T-13758

Permit amendment

Name Klamath Basin Improvement distAddress 1440 Kid lane
Klamath Falls Oregon
97603Change in ADD APPA
Date Filed 7/1/2021
Initial notice date 7/21/2021
DPD issued date _____
PD issued date _____
PD notice date _____
Date of FO 8/31/2021 Vol _____ Page _____C-Date _____
COBU due date _____
COBU Received date _____
Certificate issued _____

Figure 1: Transfer review map

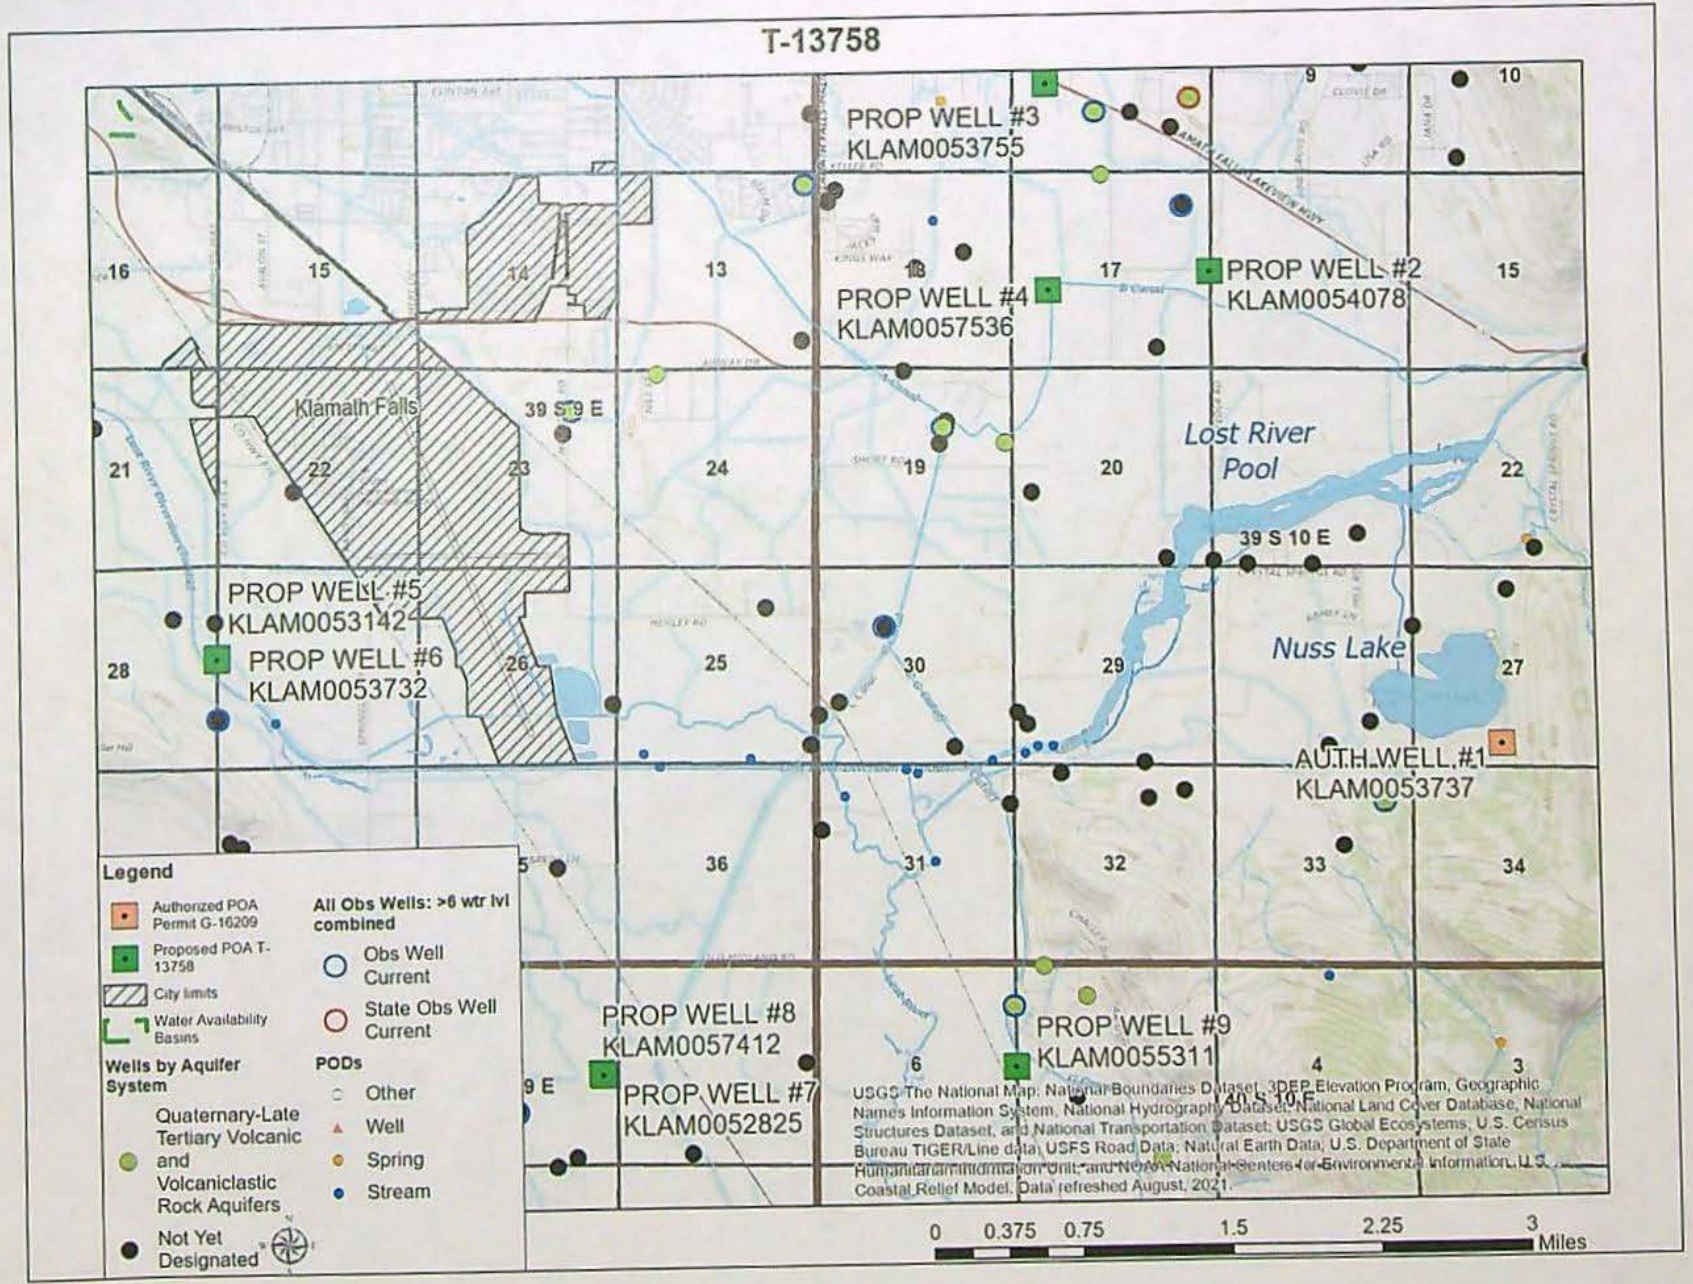
☒ The proposed change in point of appropriation is not within the same aquifer as per OAR 690-380-2110(2). This finding applies to only one of the proposed APOAs, KLAM 57536.

-
1. Basic description of the changes proposed in this transfer: The applicant proposes to add eight additional groundwater POAs to the existing permit G-16209. Permit G-16209 currently authorizes the use of 11.14 cfs from one POA (KLAM0053737) for supplemental irrigation of 8959.82 acres within the Klamath Project Area.

☒ Yes ☐ No Comments: The proposed change will move appropriation under the certificate from a single POA to eight additional POAs spread out across the area. The farthest distance moved will be approx. 6.5 miles. Overall, these changes will result in increased hydraulic interference with several existing groundwater rights in the area.

Figure 3: PyTheis hydraulic interference estimates using an evenly-distributed rate of appropriation (assumes total rate is split among all APOAs); parameter ranges taken from distribution of transmissivity values from OWRD's pump test database and literature values

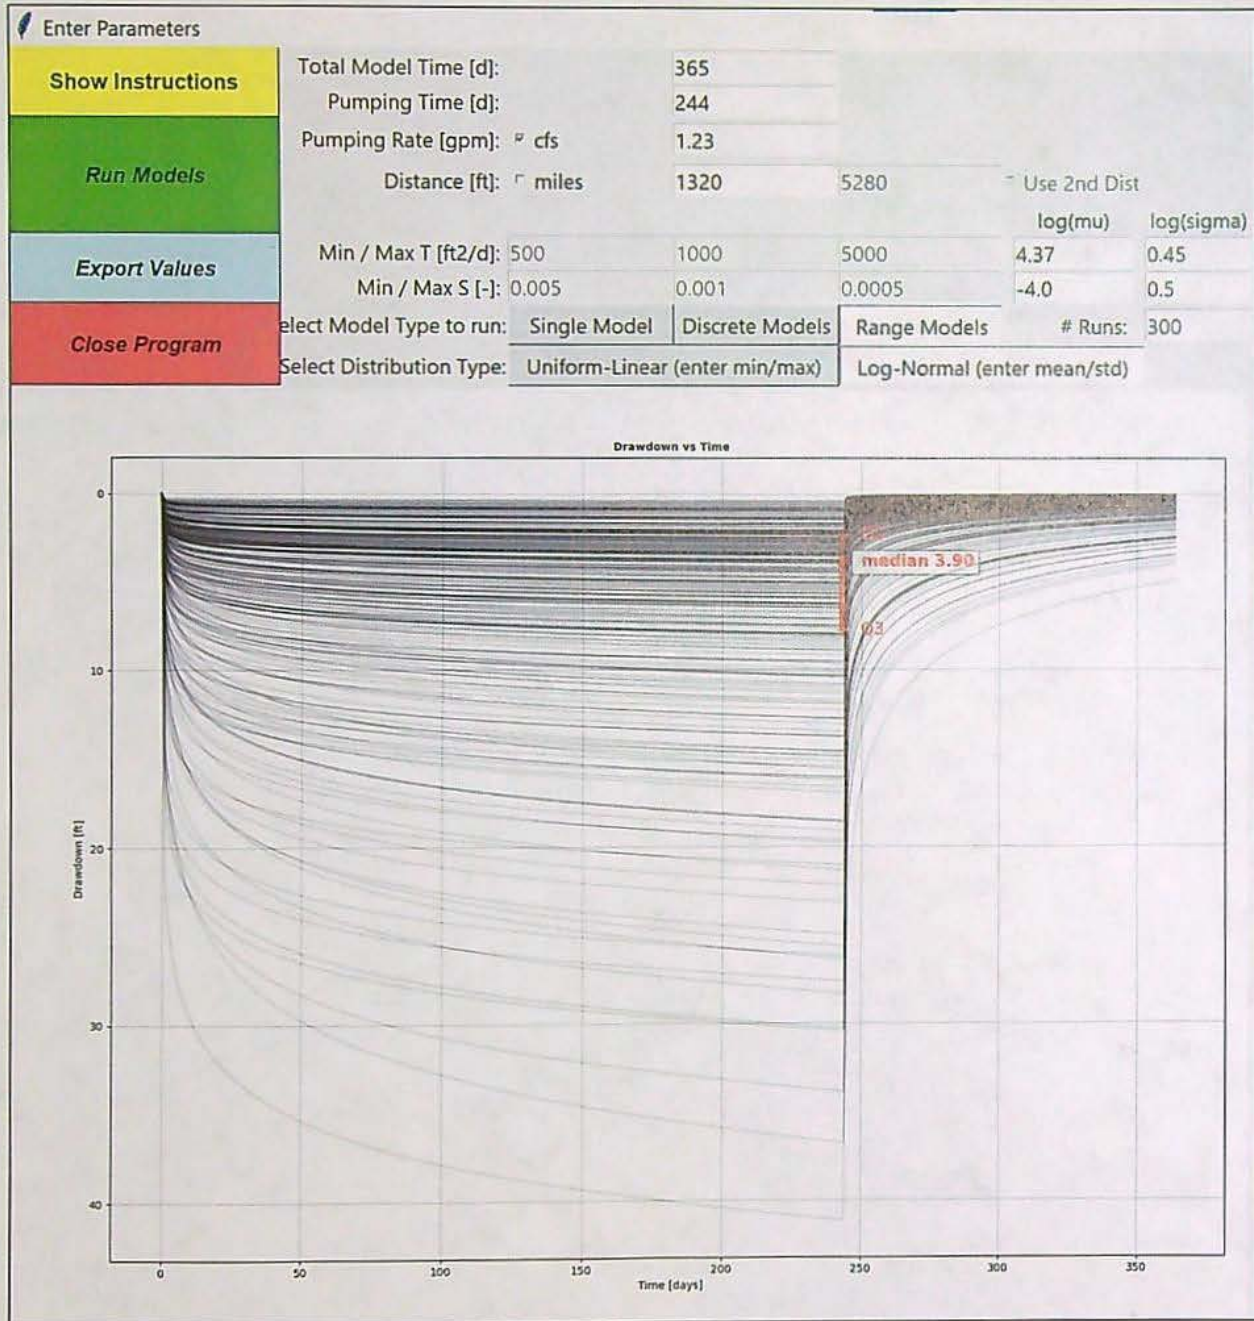
Provide context for minimal/significant impact: The thickness and low hydraulic conductivity of the sedimentary layers overlying the productive basalts in this area would inhibit significant increases in the impacts to the Klamath River that would be caused by moving appropriation under this transfer. That is to say that stream-depletion to the Klamath River caused by the current configuration of the original permit (appropriation from one well) would not significantly change under the new configuration of the proposed transfer (appropriation from nine wells).
